April 9, 1970

GAS TANK VALVE/ALL MODELS

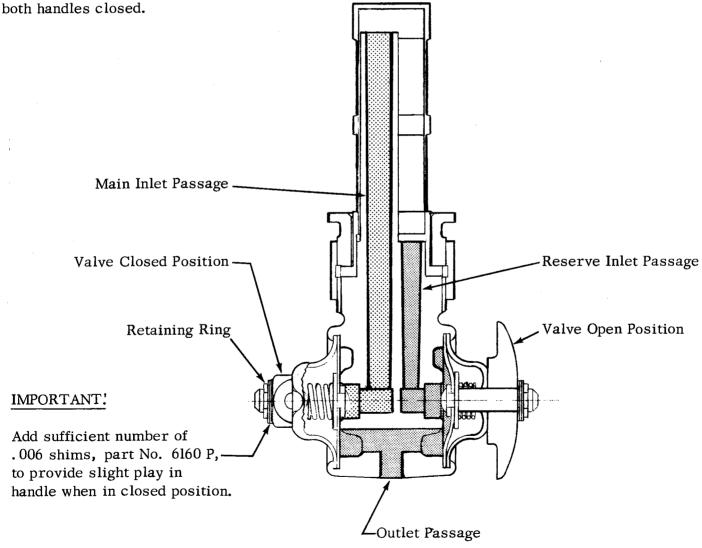
If the handle is too loose on diaphragm type fuel tank valves, it will not allow full flow of gasoline to the engine. This can result in engine slowdown because of insufficient fuel supply at high speed.

There should not be more than .010 in. clearance between the lock ring and handle when the valve is in the closed position. If there is excessive clearance, add enough .006 in. thick shims, part No. 6160 P, to provide only slight clearance when valve is closed. This will give the maximum diaphragm opening when the valve is turned on. See illustration below. After any shimming, check to see that valve does not leak fuel from outlet with
